REPLACE ROOF CIVIC CENTER

FRANKFORT, KENTUCKY

"AS-BUILT" NOTE: 25 July 2005

REPLACE ROOF -- CIVIC CENTER FRANKFORT, KENTUCKY		DRAWING NO. A-1
AS BUILT DATE 25 JULY 2005	ROOF PLAN	
DRAWN BY <i>MARTIN</i>	COMMONWEALTH OF KENTUCKY FINANCE AND ADMINISTRATION CABINET DEPARTMENT FOR FACILITIES MANAGEMENT DIVISION OF ENGINEERING FRANKFORT, KENTUCKY	
CHECKED BY <i>MARTIN</i>	WILLIAM C. MARTIN, P.S.C. ARCHITECTS-ENGINEERS 620 EUCLID AVENUE LEXINGTON, KENTUCKY	
A & B FILE 573-75	REVISED BY DATE 18 Nov. 2003	
AGENCY AUTHORIZED AGENT	APPROVED FOR PROGRAM CONCEPT ONLY DATE	
DIVISION OF ENGINEERING	APPROVED FOR PROGRAM CONCEPT ONLY DATE

SECTION G-A-5 1/2 F. S.

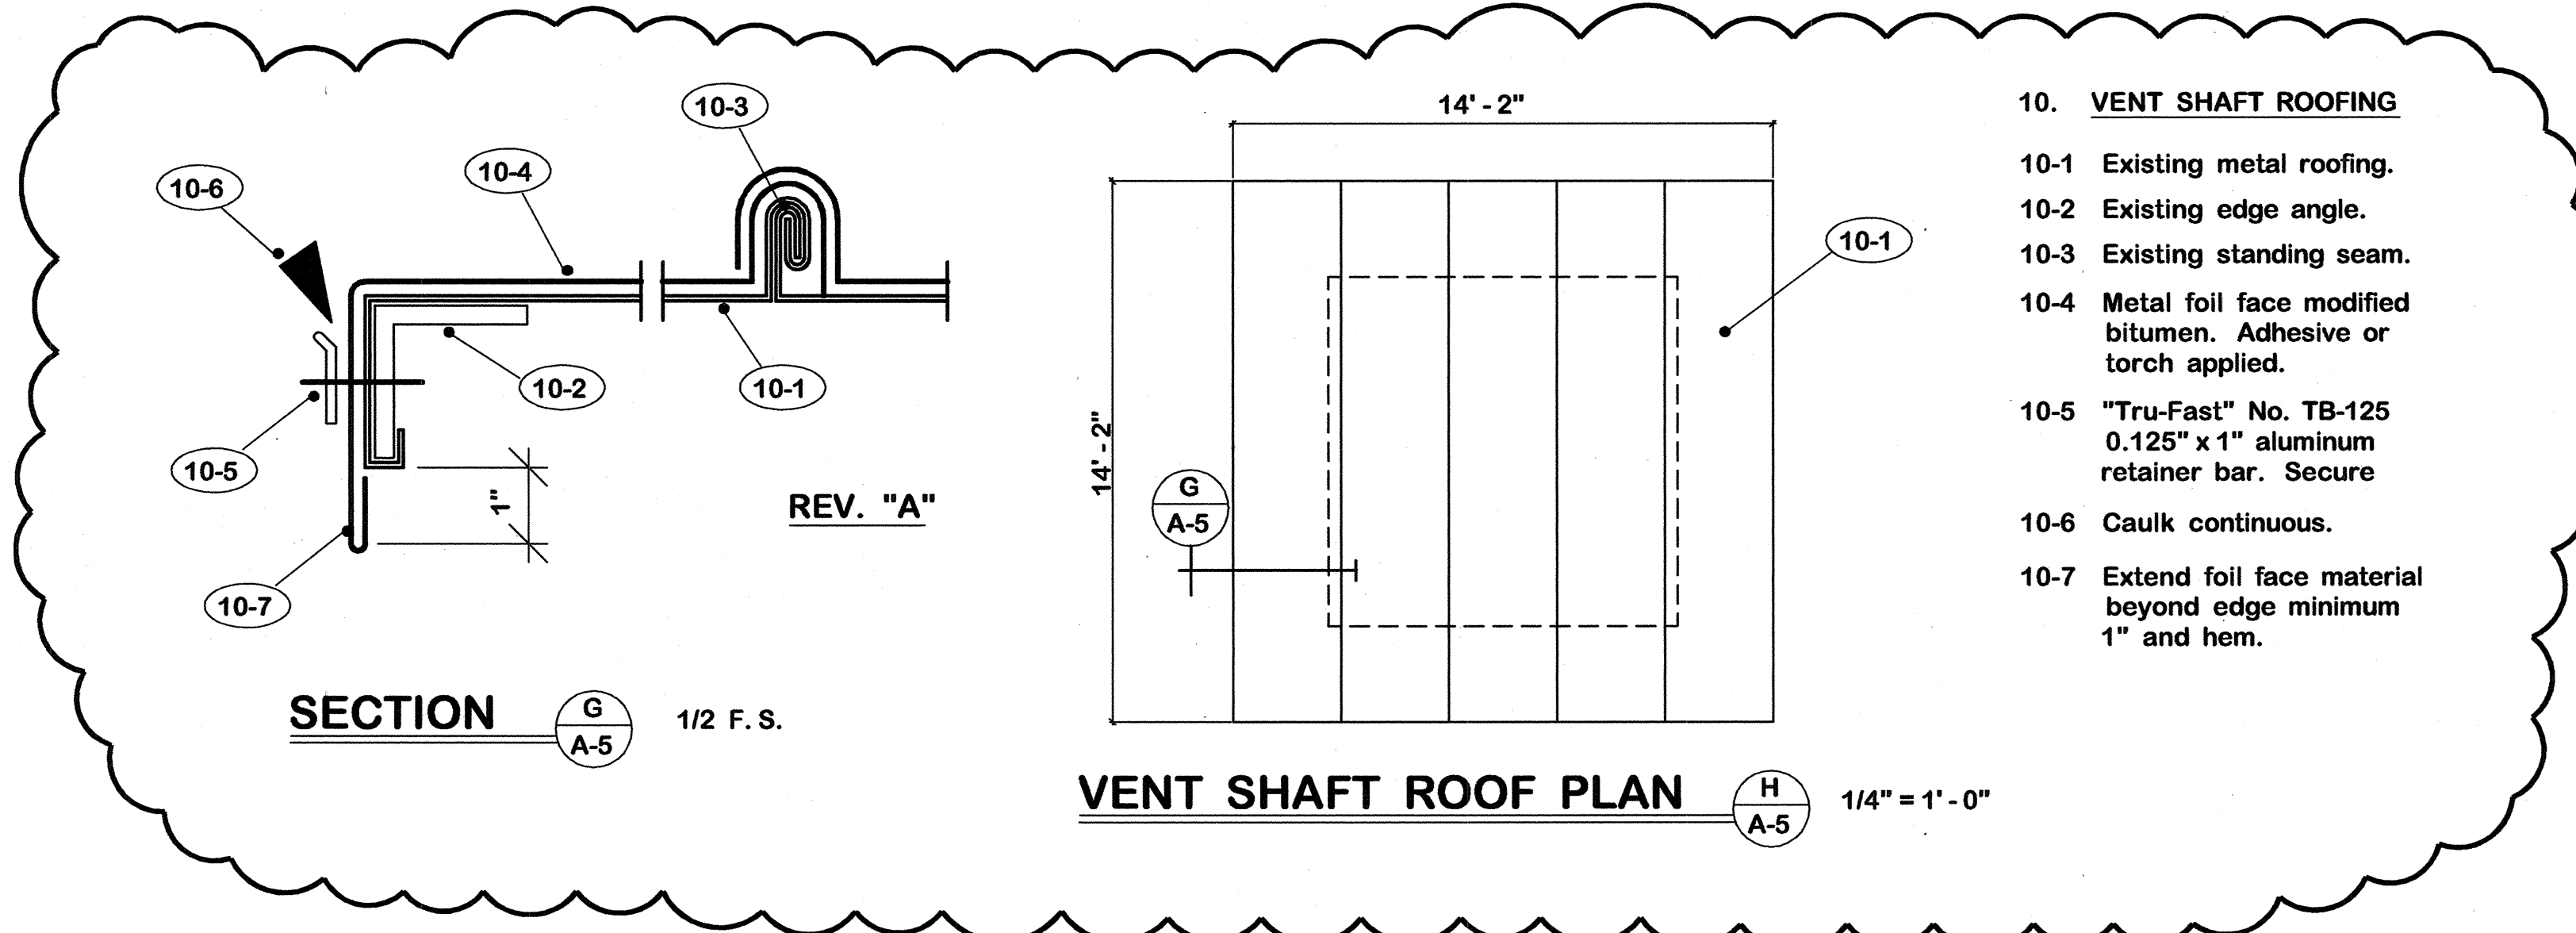
1. Revised detail D/A-5 to show 1/2" existing plywood was left in place. Changed note 6-14 to 2-21.
2. Added details G/A-5 and H/A-5. Vent shaft roof details.
3. Changed total number of drawings to 12.

SOFFIT PLAN 1/16" = 1'-0"
PLAN NORTH

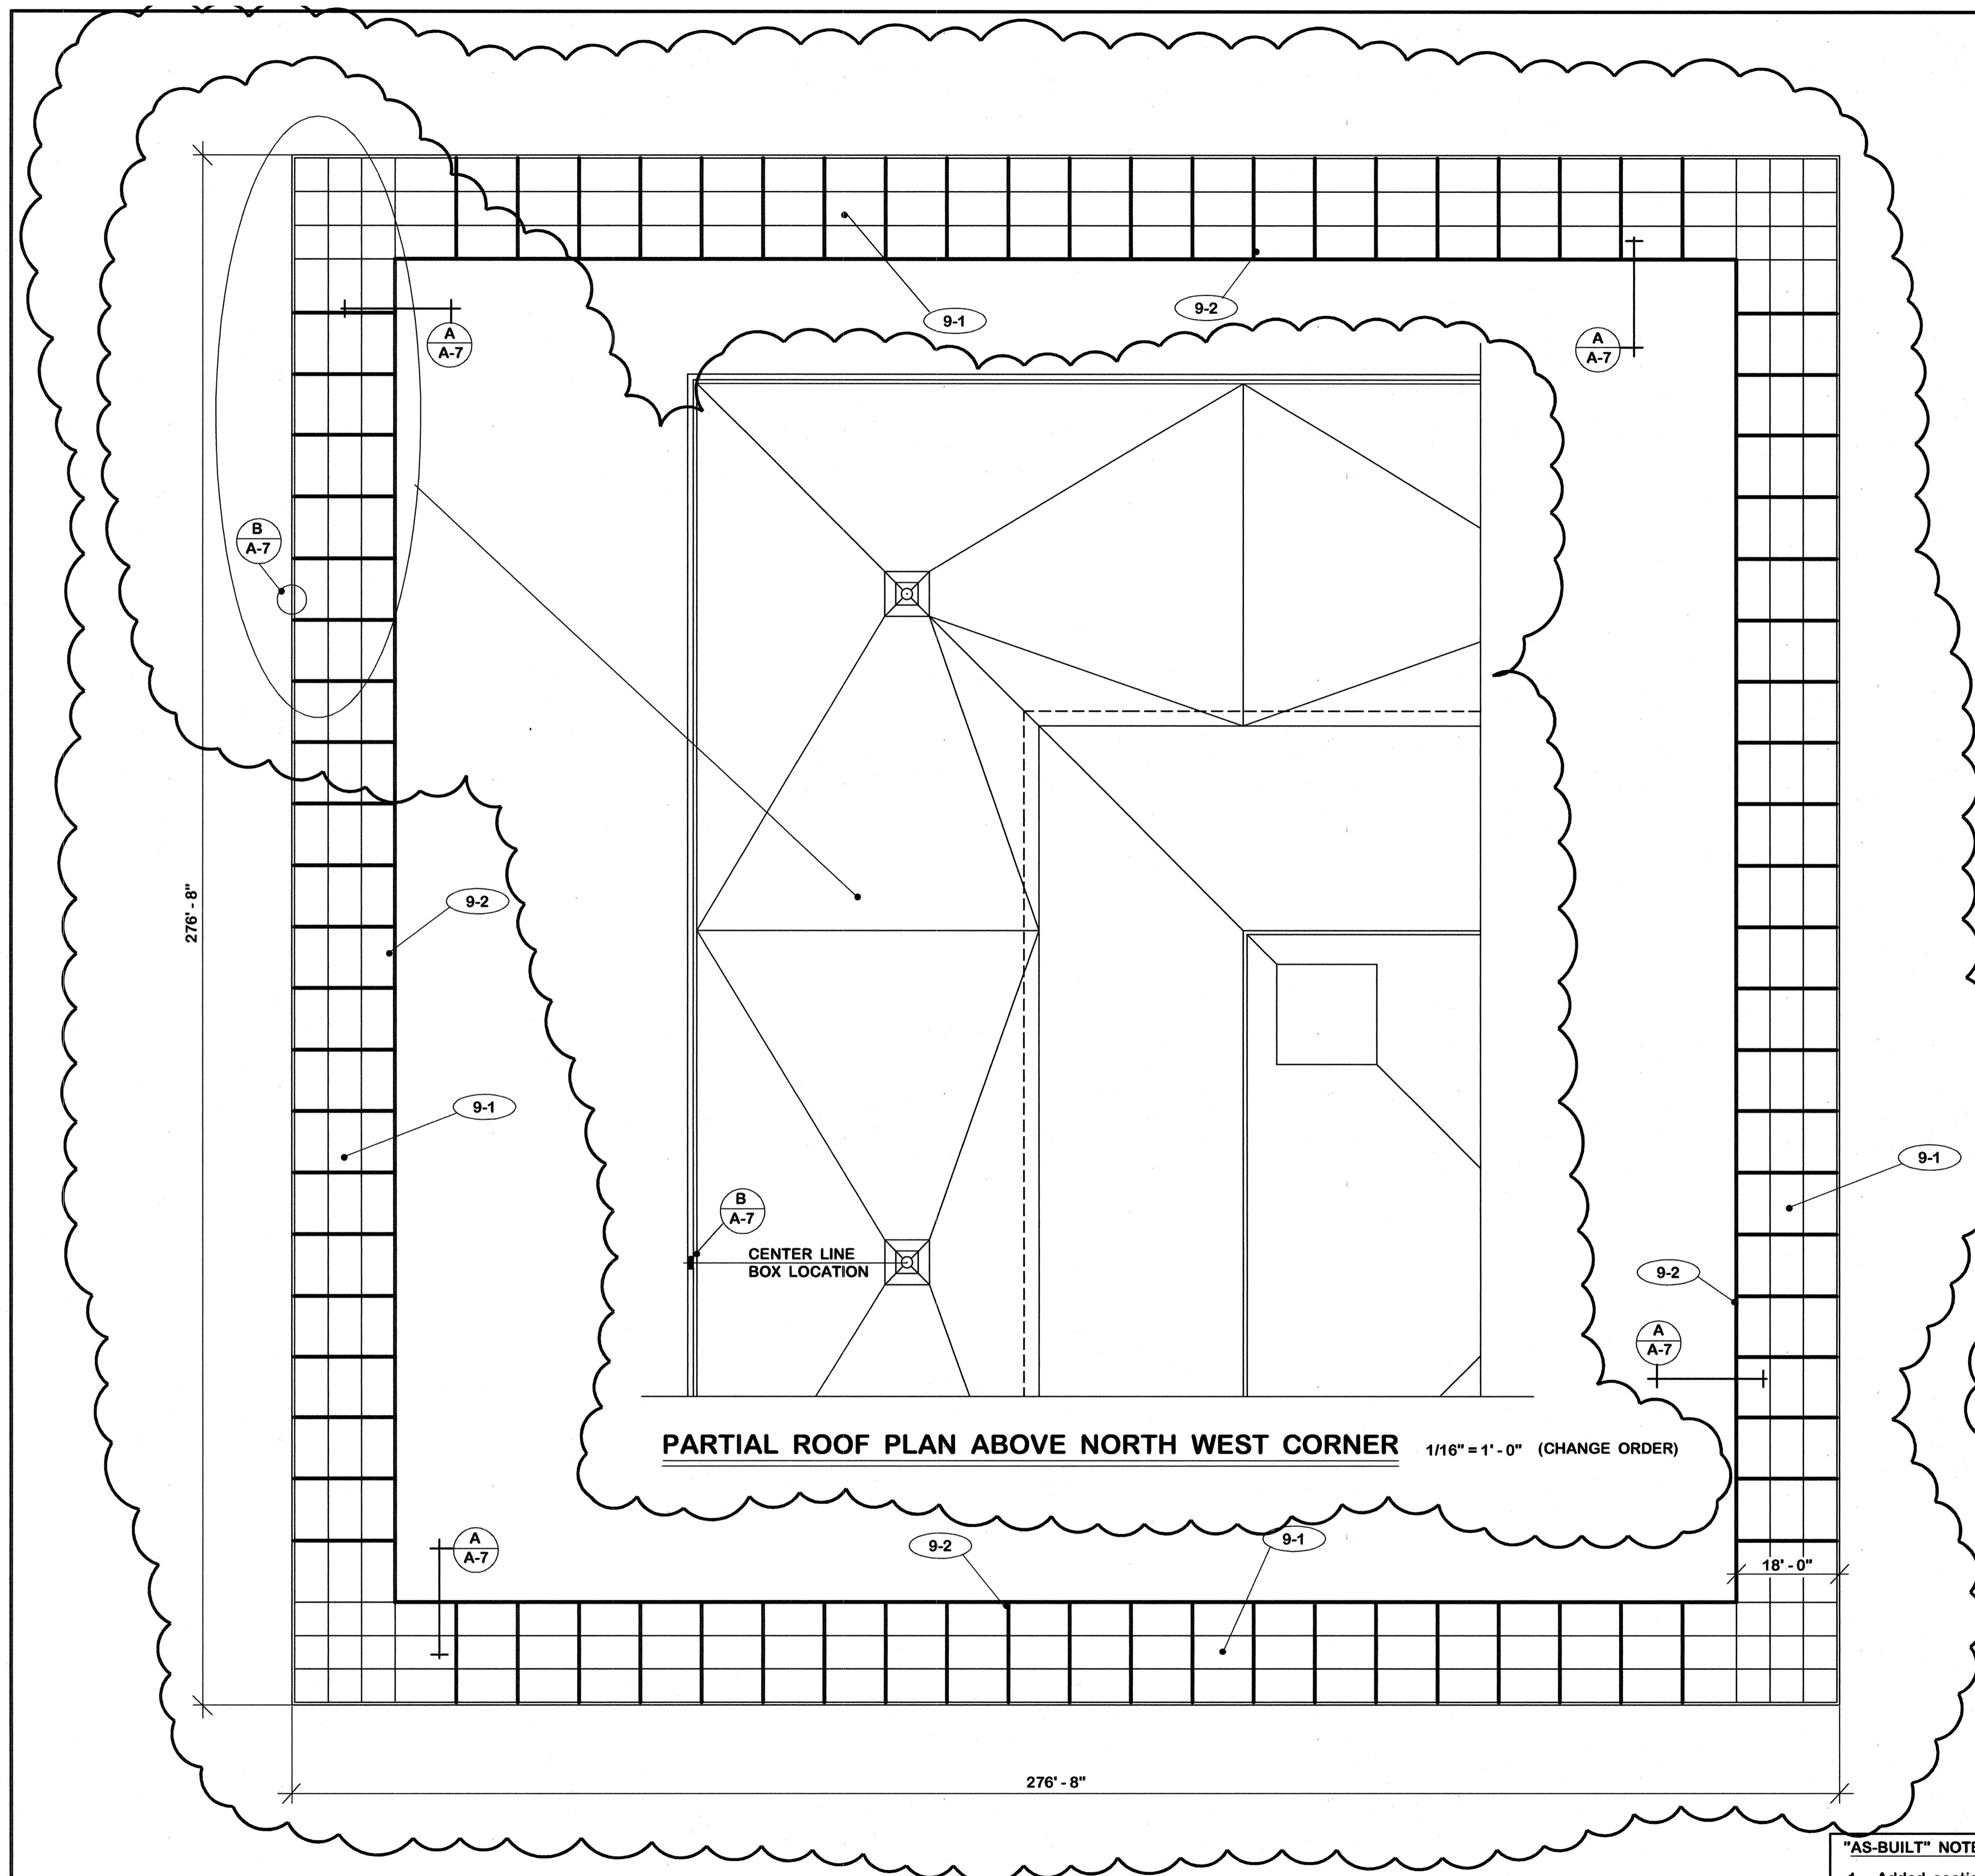
- "AS-BUILT" NOTE:**
1. Added section B/A-7.
 2. Added partial roof plan.
 3. Corrected panel layout in soffit, changed from 20 to 22 panels.
 4. Changed total number of drawings to 12.
